## **PLANNING COMMISSION MEETING STAFF REPORT**

**DATE OF MEETING:** August 12, 2025

**NAME OF PROJECT:** Julian Subdivision

**AGENDA ITEM:** Julian Subdivision – Preliminary/Final Approval

## PRELIMINARY/FINAL PLAT

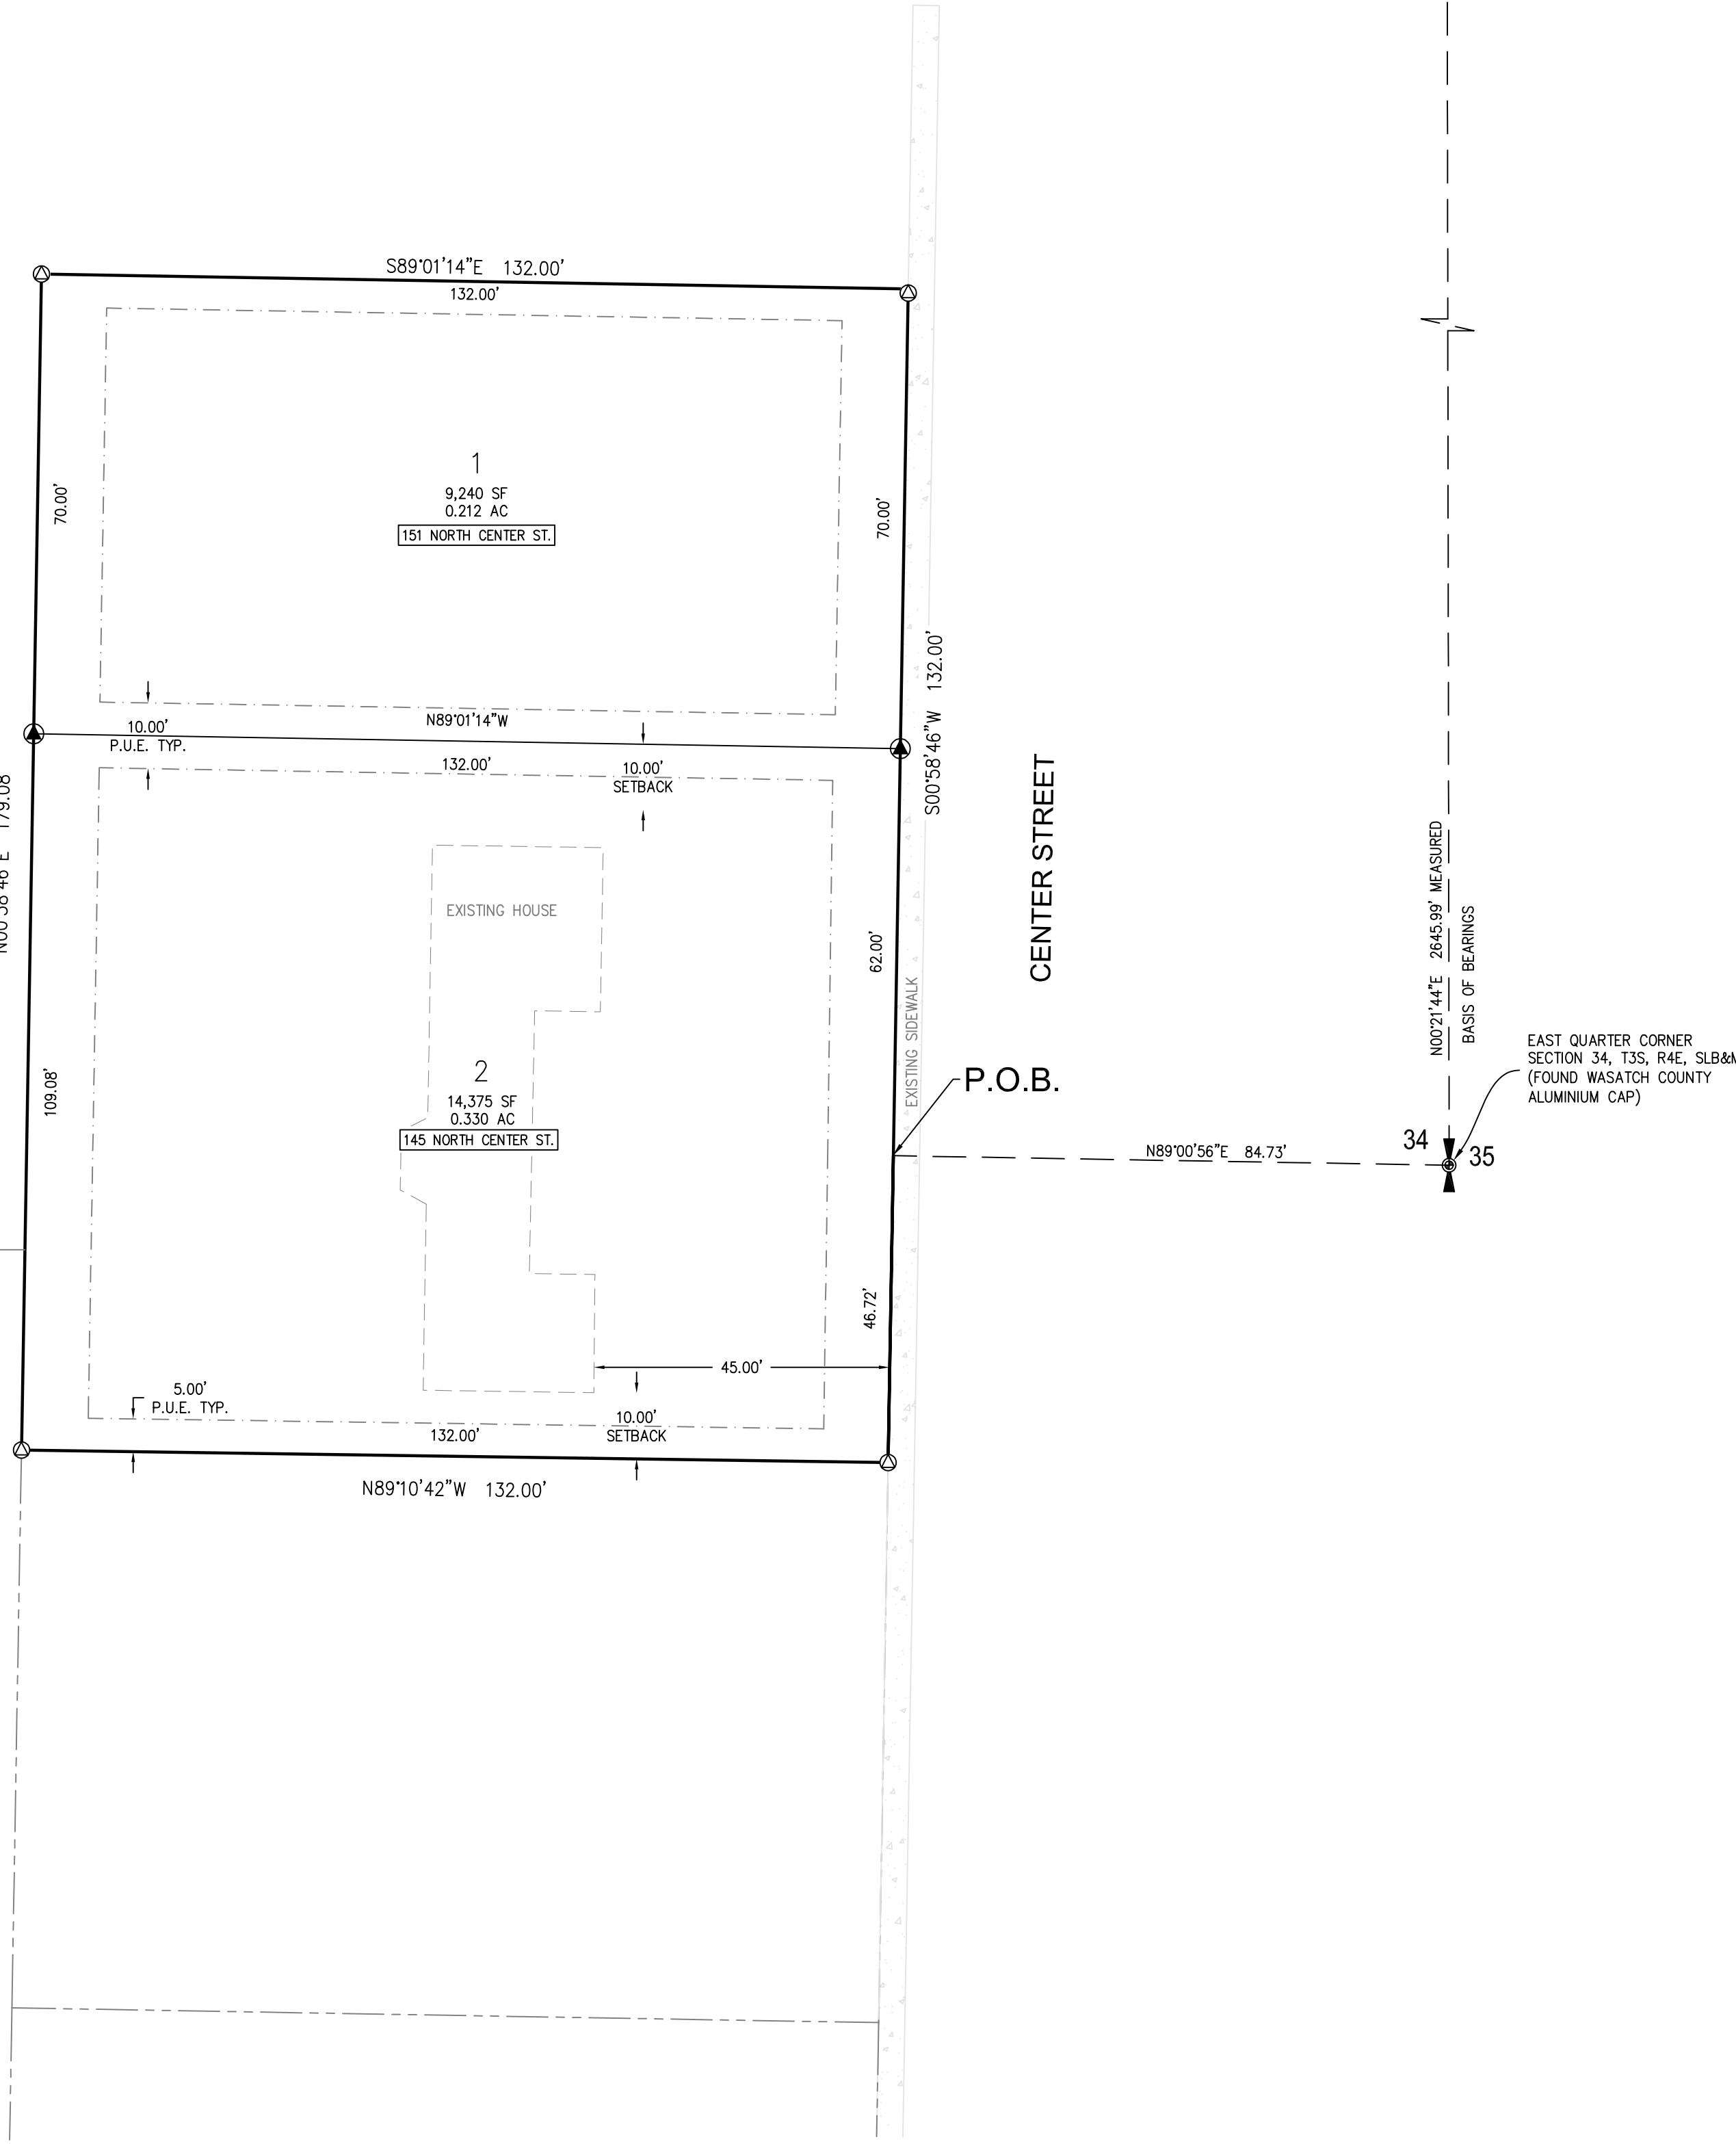
*Access* – Access both the existing lots is from Center Street, which is a collector road. Per the existing Plat, the existing Lot 1 is limited to one driveway with a turnaround to avoid vehicles backing into traffic. A similar note should be placed on the plat for any new Lot 3, limiting Lot 3 to one driveway with a turnaround to avoid vehicles backing into traffic on Center Street.

*Public Utility Easement:* A public utility easement currently runs along the perimeter of the subdivision and along the shared lot line of Lots 1 and 2. The same public utility easement (10 feet from the property line) should run along any new boundary between Lots 1 and 3 if the application is approved.

*Name:* The original Plat denotes the subdivision name as the “Julian Subdivision”. The proposed amended Plat lists the name as the “RLJ Small Subdivision, Amending Lot 1 of the Julian Subdivision”. To avoid confusion, particularly for County rescue services, the name should remain “Julian Subdivision” and any amended plat revised accordingly.

1. Any amended plat will retain the name of the subdivision as the “Julian Subdivision”. If Lot 1 is divided into two lots, the northern lot shall be denoted Lot 3 and the southern remain Lot 1.
2. Lot 1 shall continue to be restricted to one driveway access with a turnaround. A similar note shall be placed on the plat for the newly created Lot 3, restricting to one driveway with turnaround to avoid backing into Center Street.
3. Public utility easements of 10 feet will run along each side of the property line between Lots 1 and 3.
4. Water shares sufficient for the new Lot 3 will have to be dedicated prior to recording any amended plat.
